### **REMARK**

### **Drawings**

The Examiner has objected to the drawings. The following changes have been made to the drawings:

FIG. 6A

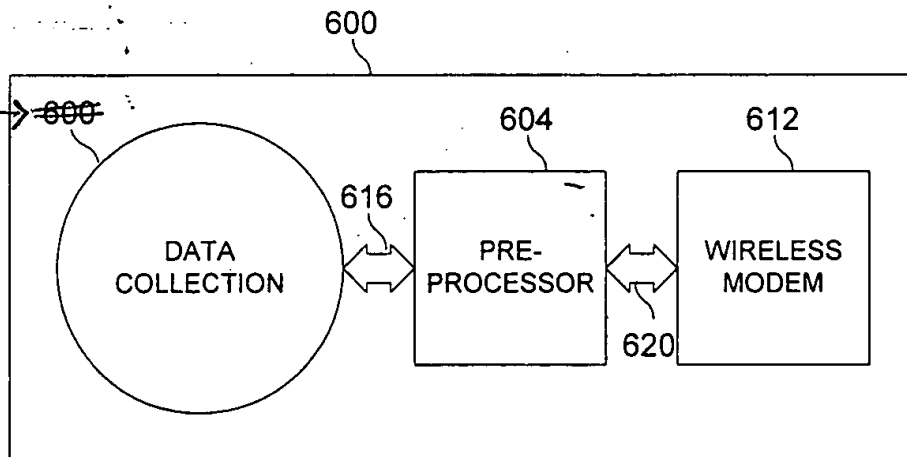
**Figure 6A** - The reference number for the data collection unit has been changed from “600” to “608”, as is indicated in the description of the drawing in the specification.
